**TOWN OF PORTOLA VALLEY
ARCHITECTURAL AND SITE CONTROL COMMISSION (ASCC)
Monday, October 27, 2014
7:30 PM – Regular ASCC Meeting
Historic Schoolhouse
765 Portola Road, Portola Valley, CA 94028**

TO: ASCC
FROM: Karen Kristiansson, Deputy Town Planner
Carol Borck, Assistant Planner
DATE: October 27, 2014
RE: Agenda for October 27, 2014 ASCC Meeting

4a. ARCHITECTURAL REVIEW FOR ELECTRIFICATION OF EXISTING ENTRY GATE, 33 GROVE DRIVE, LANDS OF JERNICK, FILE #: 36-2014

1 Site Plan

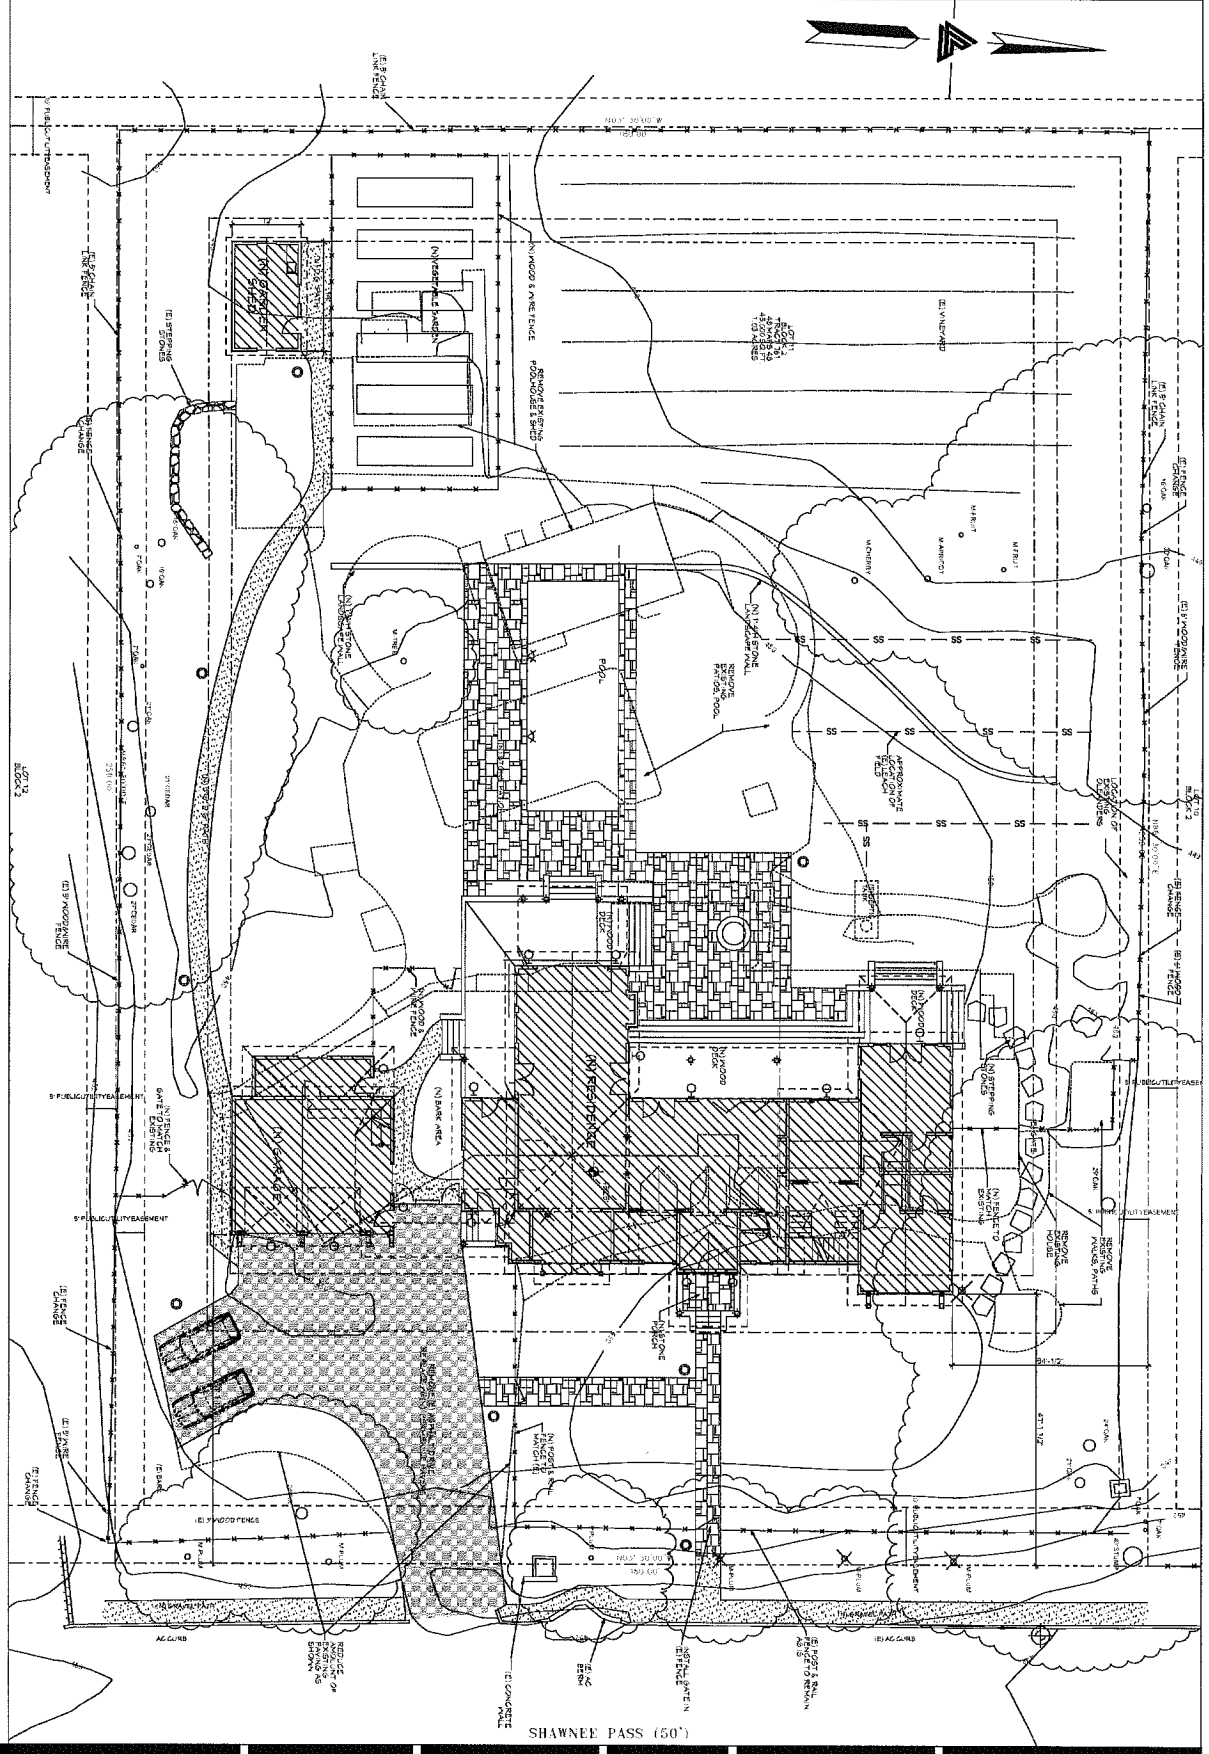
The submitted plans have been updated to include the eight-foot shift of the home away from the northern property line. This shift to the south includes the rear yard pool and patio improvements. As a result, the previously proposed carport/breezeway area has been reduced by eight feet in width and is now designated as a garden area; the two additional guest parking spaces have been eliminated. The height of the ridgeline of the breezeway has been reduced from approximately 17 feet to 14 feet. As discussed at the 10/13 meeting, moving the house further away from the northern property line will require less trimming of the existing oaks to accommodate the new structure and will also increase the buffer between the new residence and the neighboring property.

The site plan notes that the existing asphalt driveway will be resurfaced with permeable pavers. As required by the Section 15.12.310.A of the site development ordinance, the driveway surface must be asphalt or concrete for the first 20 feet measured from the edge of pavement of the existing road. The driveway/autocourt may be surfaced in pavers beyond this point. The site plan will need to be modified with the building permit, and a cut sheet or sample of the proposed pavers will need to be submitted for review and approval by staff (Conditions of

Paving for the front entry walk, rear patios, and driveway have not been specified and cut sheets will need to be submitted. The plans will also need to be revised so that the first 20 feet of driveway from the street connection are asphalt, as is required by Town regulations.

The proposed exterior lighting for the house and landscaping is shown on Sheet A-1.1 with cut sheets provided on Sheet A-1.2. The number and location of fixtures appears generally consistent with Town lighting guidelines with the exception of lighting at the entry porch and front garage elevation. Proposed lighting in these two areas could each be reduced to one fixture rather than two as proposed.

1. The proposed site plan shall be modified to show that the first twenty feet of driveway measured from the edge of pavement of the existing street or road shall be paved with asphalt or concrete.

2. The applicant shall submit cut sheets or samples for the proposed patio and driveway paving for review and approval by the Planning Director prior to building permit issuance.

SHEET TITLE
 Landscape Plan

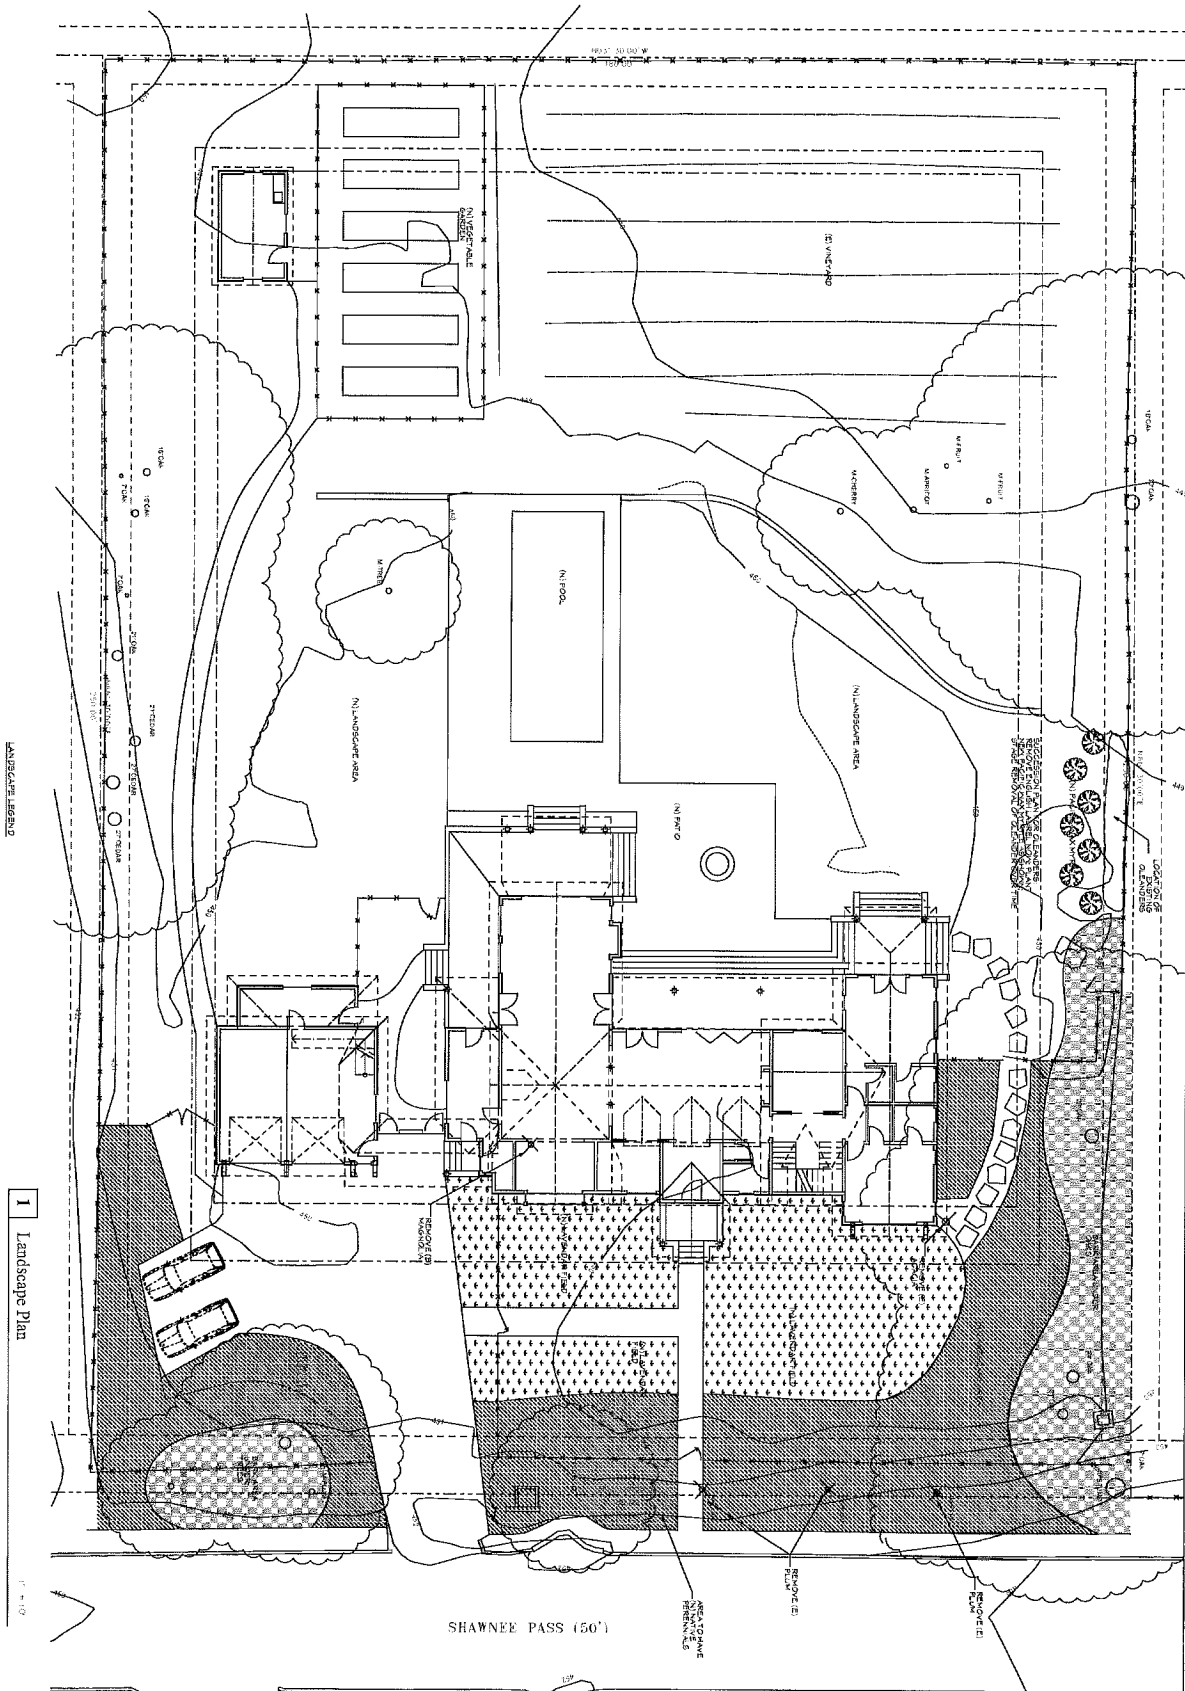
A conceptual landscape plan, Sheet L-1, has been submitted with the proposal and focuses primarily on the front yard. The proposed lavender fields remain in place with areas of native plantings providing a buffer between the lavender and the views from the street. The plan includes a list of shrubs and bulbs to be used in the area, but quantities, sizes, and specific locations have not been identified. The proposed plan shows planting beyond the front property line and into the public right-of-way which will need to be eliminated. While the plans continue to identify the three mature plums proposed for removal, they do not include the additional smaller plum trees directed by the ASCC to be removed. The plans do provide for a phasing out of the oleanders along the northern side property line, but do not state when the oleander removal would be complete. A final, detailed planting plan that addresses all of these issues will be needed with the building permit submittal.

The proposed fencing has been slightly modified to include a small extension from the existing fence at the northern side yard that will connect with the northern home elevation and that the existing front yard fencing is remain in place. However, the plans do not include any changes to the rear property line chain link fencing or the hedge-like plantings located along it. The ASCC had asked the project team to modify the chain link fence so that it conforms to Town height regulations and is more fitting in appearance with Portola Valley. Additionally, it was suggested that the landscaping in this area could be modified to remove some of the existing linear plantings and new, native plants could be installed randomly to enhance the screening of the fencing.

3. A final, detailed planting plan addressing the issues set forth in the October 27, 2014 staff report shall be submitted for review and approval by a designated ASCC member prior to building permit issuance.

A-4

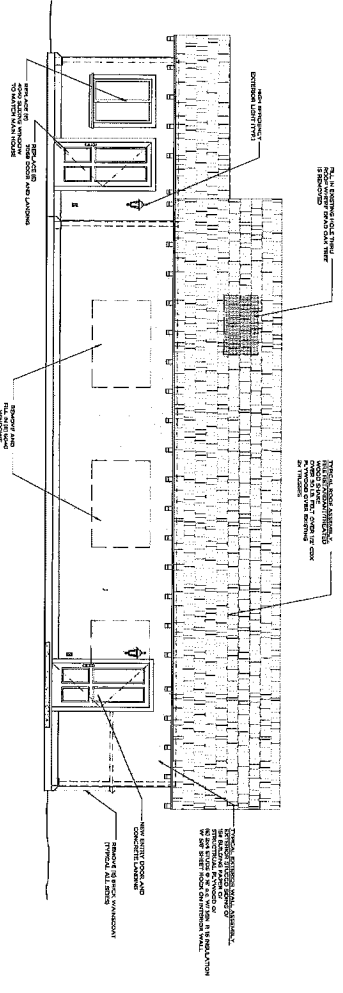
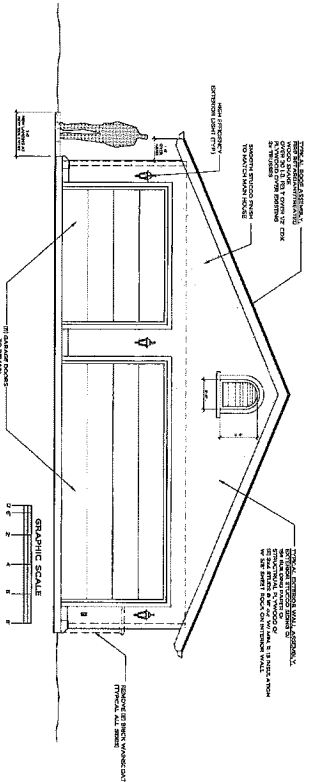
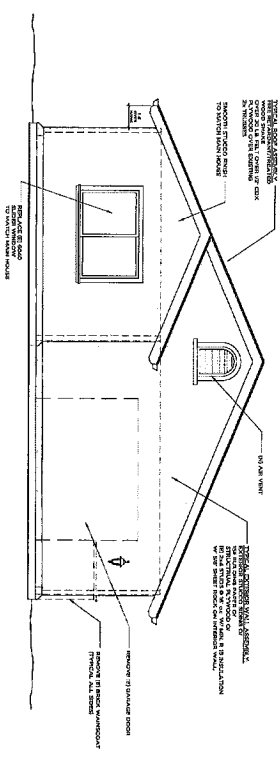
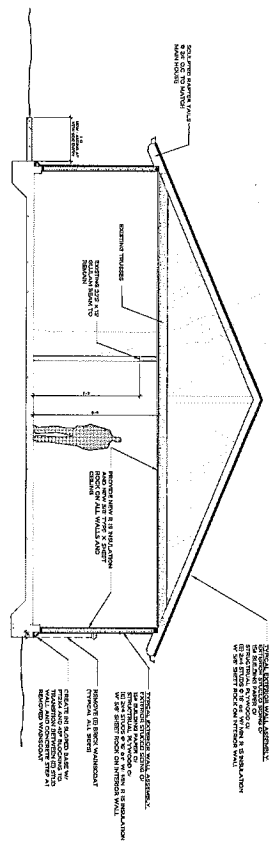
The proposed exterior lighting for garage is shown on Sheet A-4. The proposed fixture is a carriage style sconce with frosted glass; however a cut sheet for the specific fixture has not been provided and will need to be submitted with the building permit. The proposed number and locations of fixtures on the remodeled garage appear to be in general compliance with Town lighting guidelines with the exception of those proposed for the front elevation. There are three sconces proposed along the garage face, whereas it would appear that two fixtures could provide adequate lighting in this area. There is an existing floodlight at the rear of the structure that will need to be removed with the remodel.

1. The cut sheet for the proposed exterior sconce light shall be submitted to the satisfaction of Planning staff prior to building permit issuance.
2. A construction staging and tree protection plan shall be submitted to the satisfaction of Planning staff prior to building permit issuance.
